To: **Planning Reps**
From **Highways Development Management Officer**

Your Ref 20220773

Location 83 Chalk Road, Gravesend, Kent, DA12 4UT

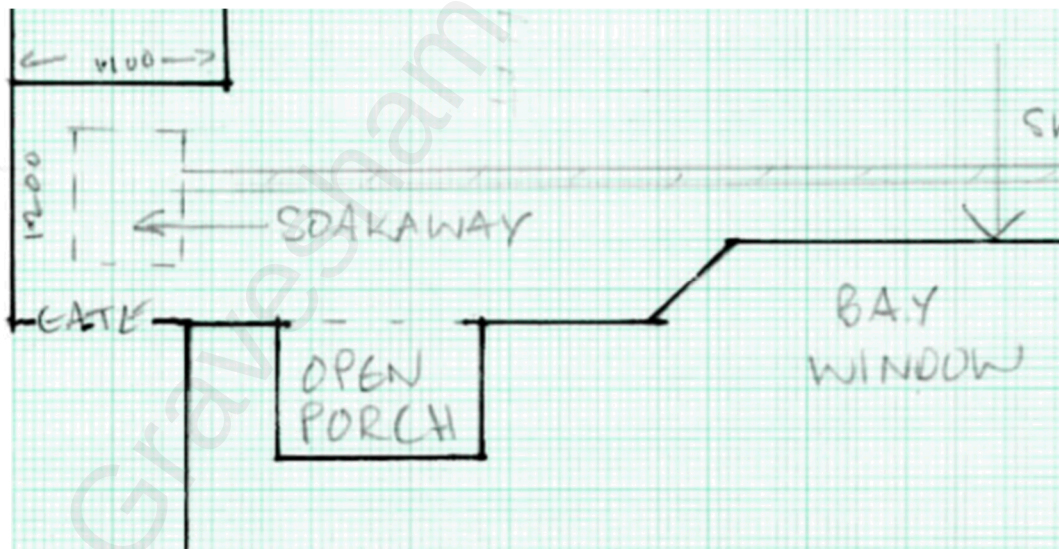
Here the soakaway would be adjacent to the building.

In addition, to be acceptable the drive way would have to have direct access for each vehicle onto the highway, resulting in an access width of 5.4 metres minimum and not the 3.74metres shown, as this would seriously impede access to one of the vehicle parking spaces. Alternatively, provision could be made for just a single vehicle and more space given over to soft landscaping.

If the construction were changed to a bound permeable paving, with the slit drain discharging its water over a wide area into the sub-base of the drive, it may be acceptable in drainage terms, but the installation would have to comply with the requirements of the material supplier.
